INITIAL FIRE SAFETY INSPECTION REPORT

Shanta Expression Limited (Extension)

RSC ID: 26005

Date: 26-Feb-2025

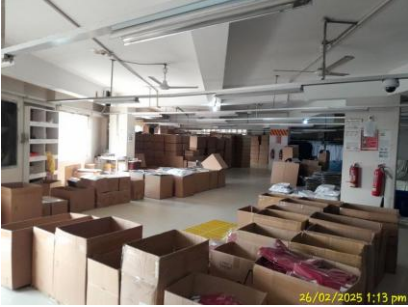
F-2	Mean of Egress	The building did not have stair designation signs at the required locations. Location: All floors.	Provide stair designation sign at at each floor entrance from the stair to the floor in English and Bengali. Signs shall indicate the name of the stair and the floor level. Signs shall be posted adjacent to the door in accordance with RSC Technical Guidelines (Standard), Section 6.9.3.	Within 1 month
F-3	Mean of Egress	Exit stairs serve more than 5 stories and do not have required re-entry provisions on all floors.	Every door in a stair enclosure serving more than 5 stories shall be provided with re-entry unless it meets RSC Technical Guidelines (Standard) 6.8.3.1.	Within 1 month
